# Japan Comments for EC Proposal about Battery Durability

12.December.2019

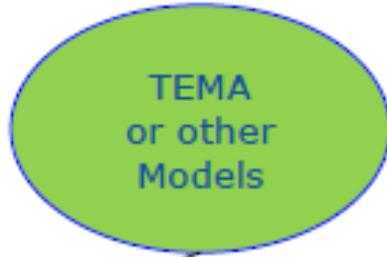
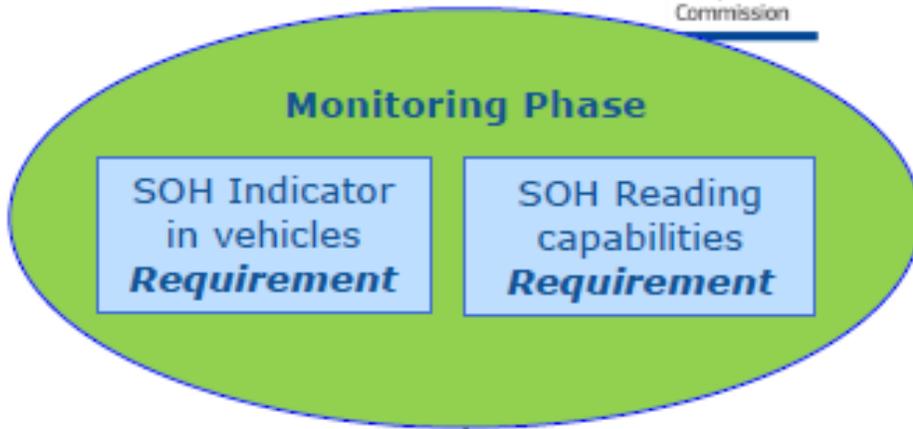
Screened by conditions of use. How?

Severely used batteries' Data can be removed

Firstly distribution are needed. Then decide DF.

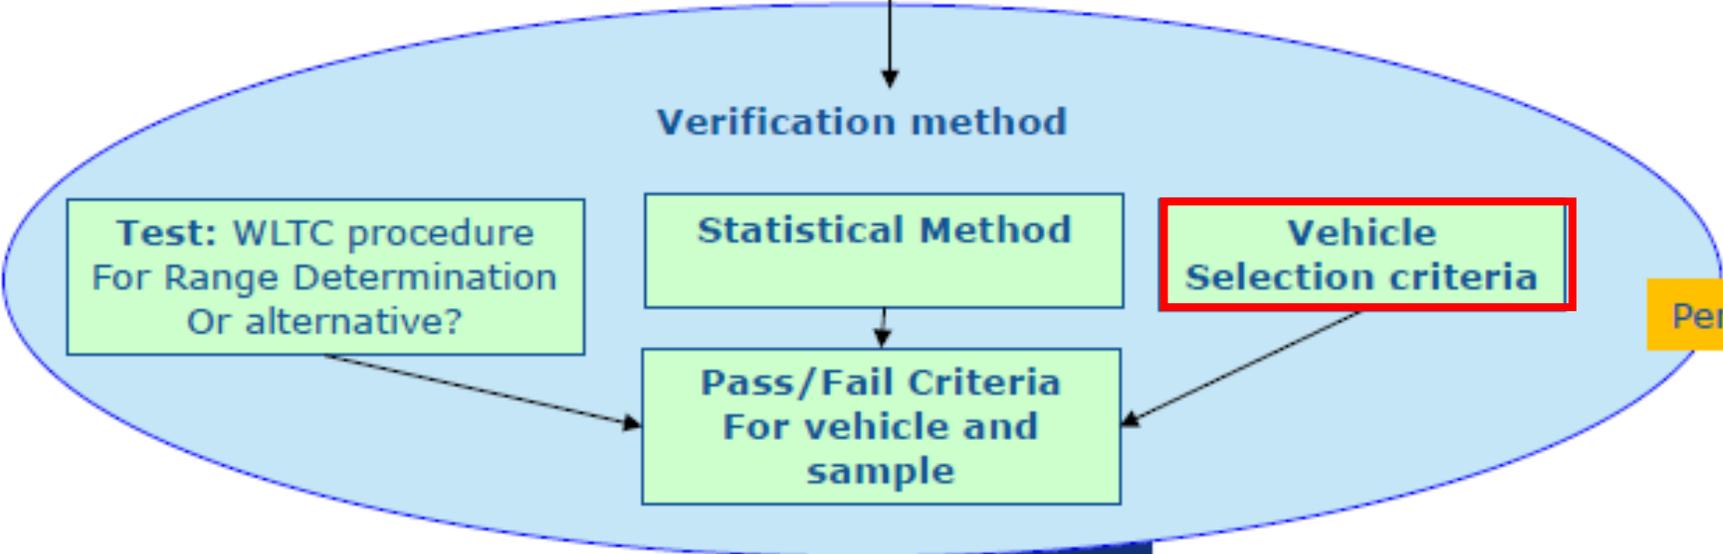
Request to add

Vehicle Selection Criteria
